Your Reference: MP11_0009 (Part 3A Application)

Proposal: Miranda Dental Hospital at 84-86 Kiora Road, Miranda

I refer to your email of 4 May 2012 inviting Council to make a submission in regard to the submitted Preferred Project Report (PPR), and requesting Council to provide without prejudice conditions of consent.

41. Use of Inpatient 'Studios'

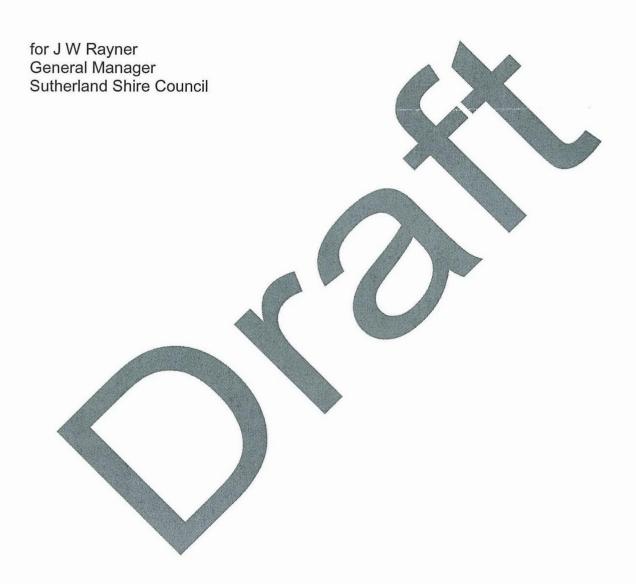
The nurse's station on Level 5 must be staffed whilst any of the inpatient suites (shown as "Studios") are in use for inpatient accommodation. These rooms shall only be used for inpatient accommodation and are not to be converted, used or adapted for any other use, such as storage, overnight staff or specialist accommodation, or the like.
